Product Change Notification

Date Issued :	February 28, 2024	PCN Number :	514903
Reason for Change :	Change to Product		
Description of Change :	This notification is to inform you about changes that are being made to the part(s) as identified in the list. This change will not affect the Fit, Form, Function, or appearance of the parts. This does not affect the specification of the final assembly/finished good.		
Assessment of Change :	Dimension analysis		
Planned Implementation Date :	September 13, 2024		
Customer Sample Availability Date:	June 14, 2024		
Last date to request Samples by Customer :	May 31, 2024		
Please note if Samples are not requested as per Customer Samples Request date, it may take additional 4-6 weeks to arrange Samples.			
Traceability Code Markings / Date :	Date code

Overview

After Picture

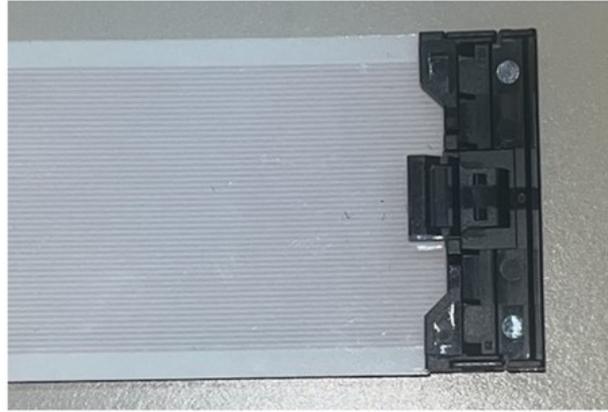
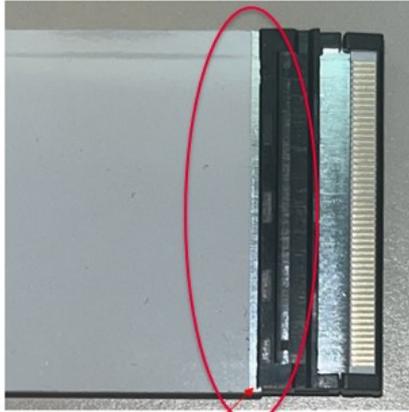
White jacket is pulled back so no interference with clips. This will call a small amount of the shield to be exposed at the edge of the clips as seen above.
